Access Compliance Report

Public Rights-of-Way

Intersection ID: 13829	Main Street: E_MOREHEAD_ST	Cross Street: DILWORTH_RD	Location:	N
ADA ID: 8429AACAC148	Ramp Type: Perp	Initial Pass/Fail: Fail	Overall Compliance: No	Severity Score: 25

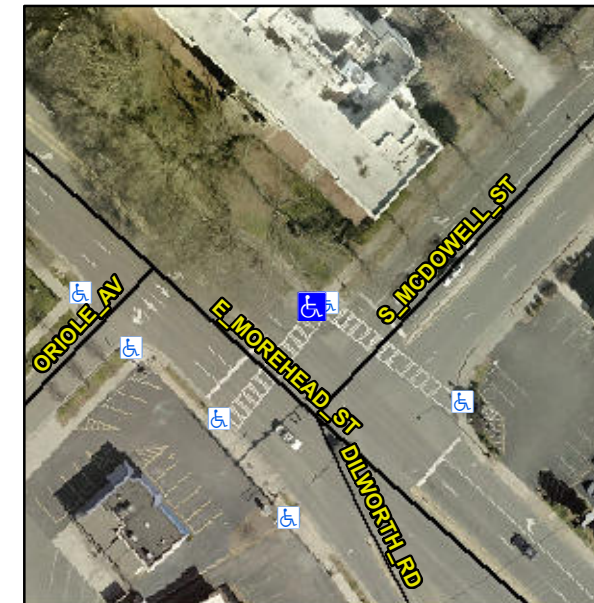
Not Found, R304.2.2, R304.5.3

Compliance	Description	Data	Compliance	Description	Data
N/A	Ramp Length (in)	124.0	No	Ramp Slope (%)	9.3
Yes	Ramp Width (in)	93.0	No	Ramp XSlope (%)	5.8
N/A	Flare Type LT	N/A	N/A	Flare Type RT	N/A
N/A	Flare Slope LT (%)	N/A	N/A	Flare Slope RT (%)	N/A
N/A	Flare Traversable LT?	N/A	N/A	Flare Traversable RT?	N/A
N/A	Landing Length (in)	N/A	N/A	DWS Provided?	N/A
N/A	Landing Width (in)	N/A	N/A	DWS Contrast?	N/A
N/A	Landing Slope (%)	N/A	N/A	DWS Length (in)	N/A
N/A	Landing X Slope (%)	N/A	N/A	DWS Full Width?	N/A
N/A	Landing Curb? (Y/N)	N/A	N/A	DWS Offset (in)	N/A
N/A	Shared Landing?	N/A			
N/A	Gutter Ponding?	N/A	N/A	Gutter Slope (%)	N/A
N/A	Gutter Lip Ht (in)	N/A	N/A	Gutter X Slope (%)	N/A
N/A	Painted X Walk1?	Yes	N/A	Painted X Walk2?	N/A
	X Walk 1 Direction	To SW		X Walk 2 Direction	N/A
N/A	X Walk 1 Width (in)	106.0	N/A	X Walk 2 Width (in)	N/A
	X Walk 1 Slope (%)	3.1		X Walk 2 Slope (%)	N/A
	X Walk 1 X Slope (%)	1.9		X Walk 2 X Slope (%)	N/A

Remove & Replace Entire Ramp.
